Addendum No. 1

Reference: Multiple Solar PV Facilities at Camp Williams, Draper HQ, West Jordan,
Blanding, and St. George
Utah National Guard
DFCM Project No. 14261480

Date: July 1, 2014
 To: Design/Build Teams
 From: John Harrington - Project Manager
 Reference: **MULTIPLE SOLAR PHOTOVOLTAIC FACILITIES**

Questions and Answers as a result of Mandatory Site visits on June 24 and 25, 2014

Ref: Utah National Guard; West Jordan, Utah
Subject: Solar Panel Roof Evaluation

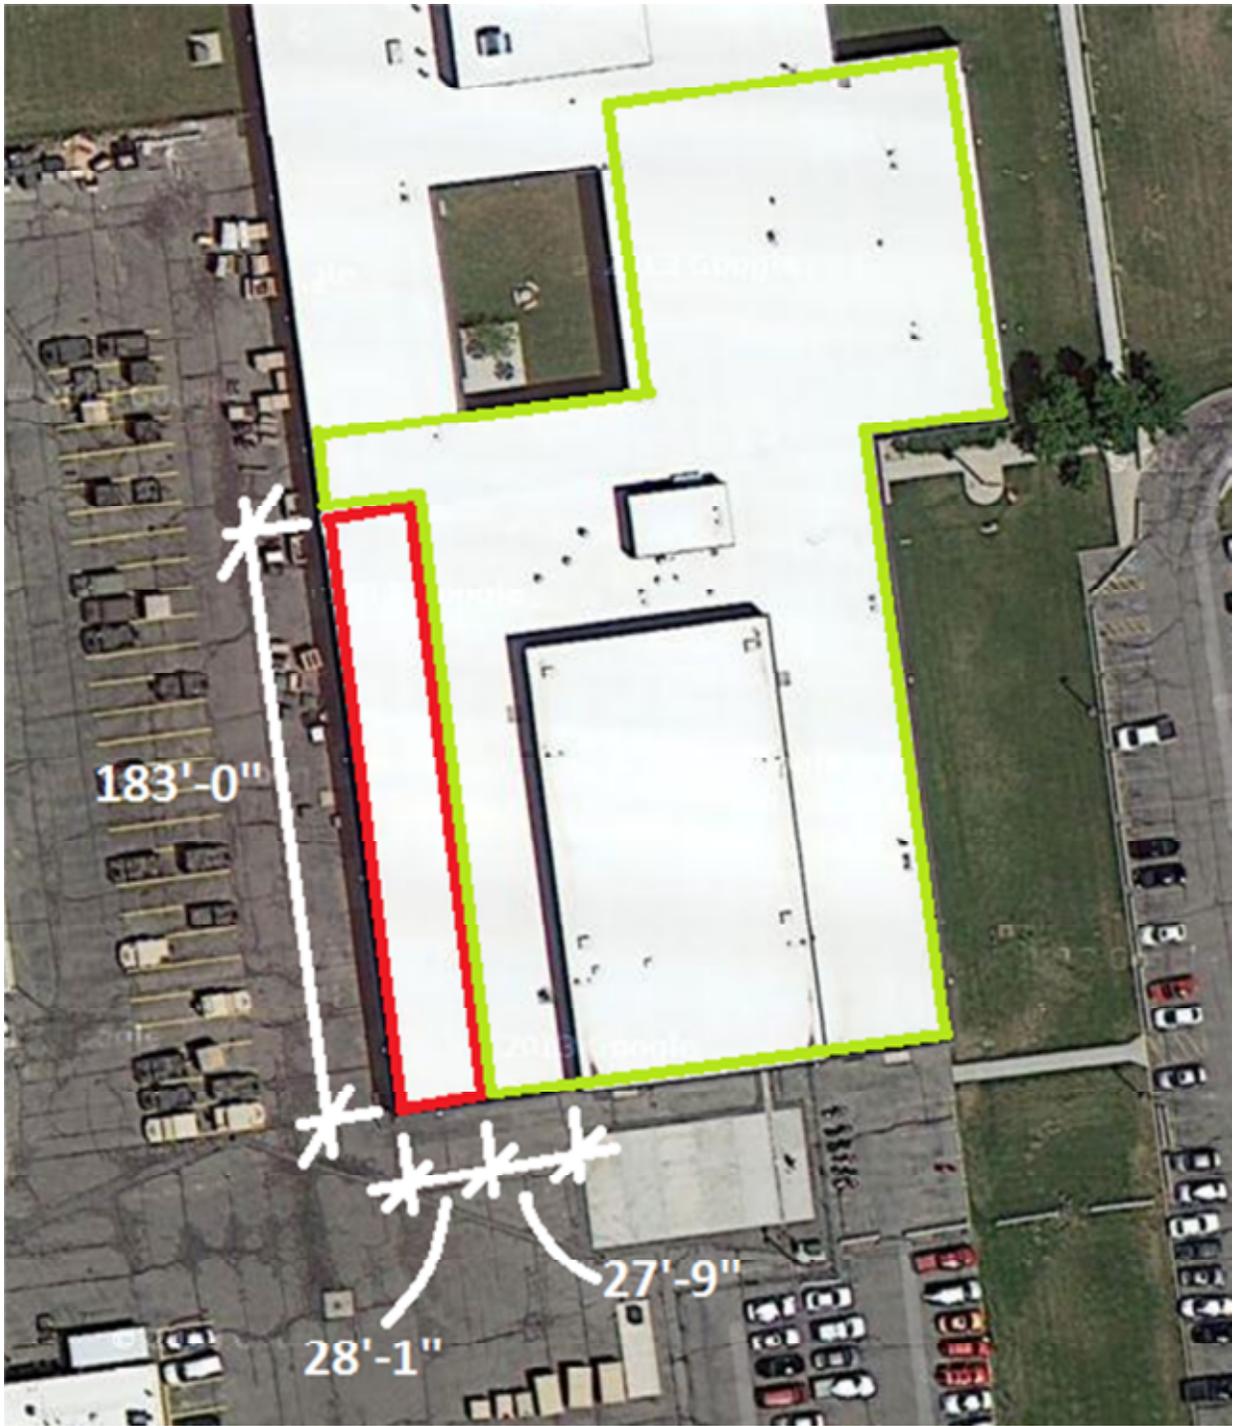
All of the proposed locations for the solar panels, with the exception of one bay, have ample available capacity based on these loads. The westernmost bay on the south end of the building (a 183'-0" x 28'-1" rectangular area) is the area that doesn't have capacity to support the approximately 5 psf of added weight for the solar panels. The location of this bay can be seen in the aerial image attached, which outlines the acceptable locations in green and outlines the unacceptable areas in red.

UPPER AND LOWER ELECTRICAL SITE PLAN
 SHEET NUMBER
ES101

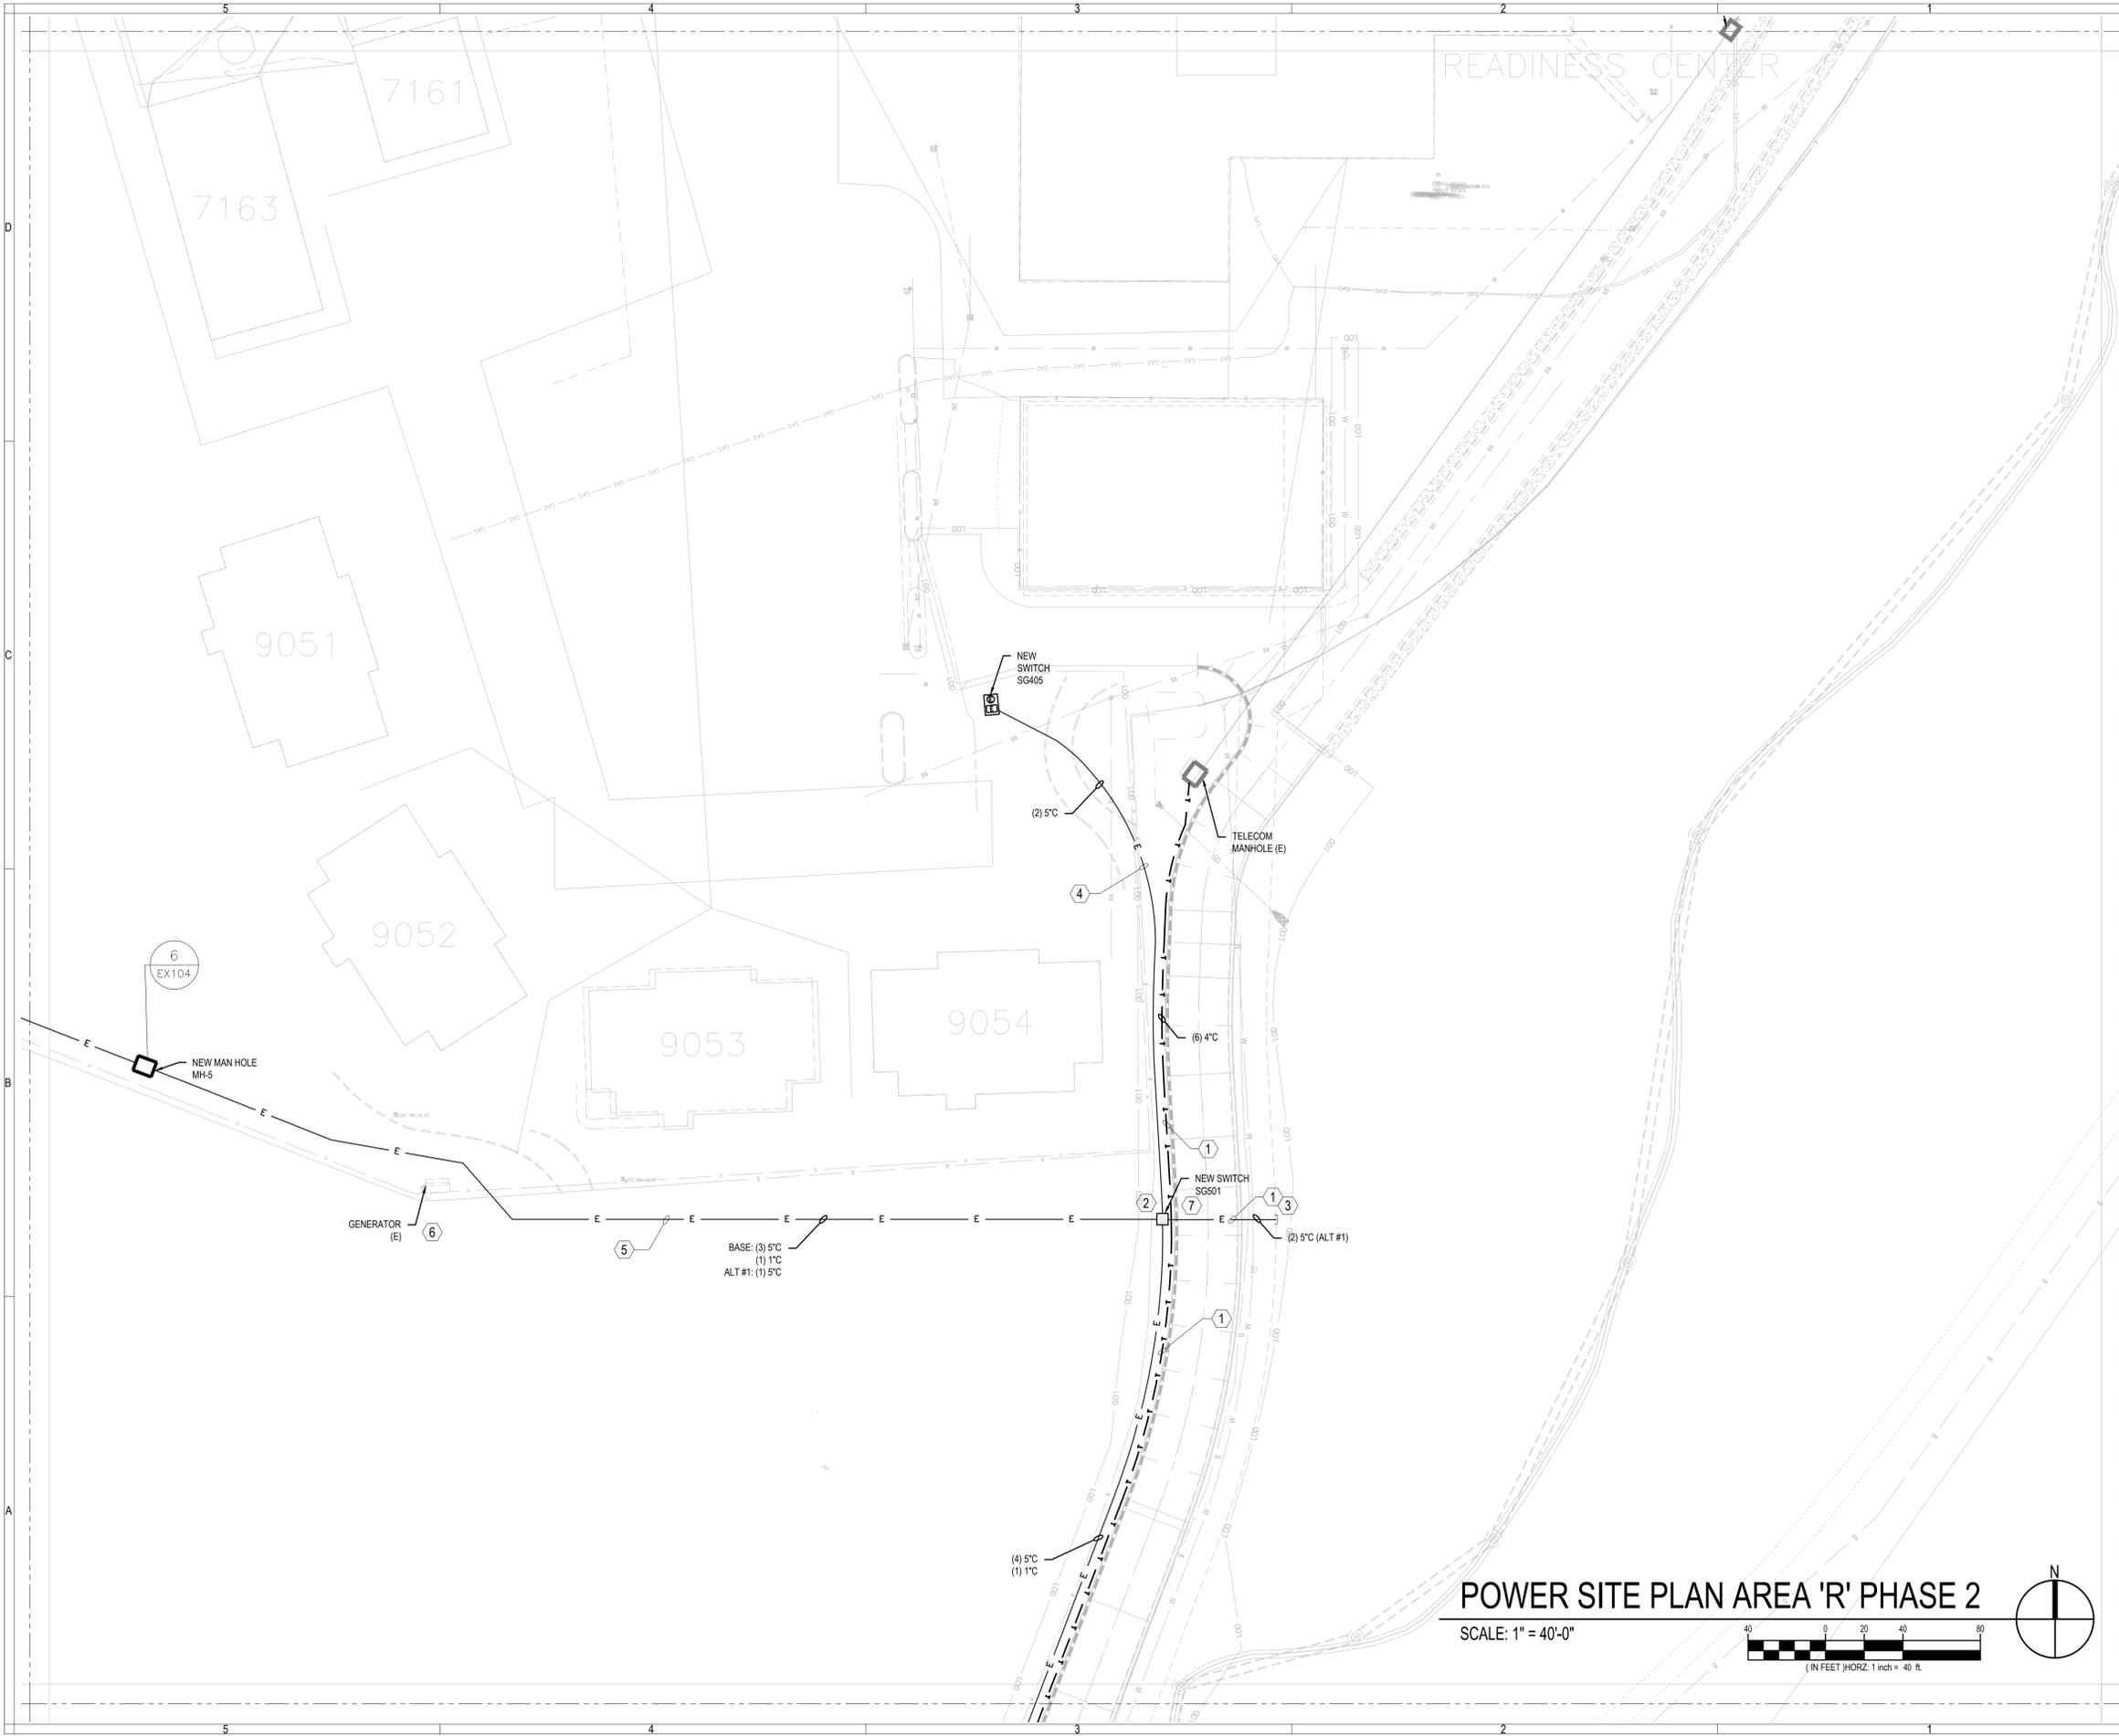
Question	Answer
1	The new MV conduit and trenching from north to south will have manholes at 600 feet according to the briefing. Can you locate the relevant manholes on a map?	Drawings are included for download (“Camp Williams Infra Project.pdf”)
2	Please verify the enclosed Jacobs Canal is under the gravel road?	The enclosed Jacobs Canal is under the gravel road.
3	If we can construct the system with minimal clearing, grubbing and grading, can we include this as part of our erosion and weed control solution? It is possible to minimize soil disturbance and minimize erosion in the out years.	For the purpose of the bidding, please assume that the specification for the ground underneath the array is as follows: Include a weed barrier that is to be pinned, with a minimum of 3” gravel (¾” crushed) covering the entire surface area. For the barrier, we request a 20 year (4.1 oz) woven polypropylene (or equal), needle punched landscape fabric. Clearing, grubbing and grading is the responsibility of the contractor.
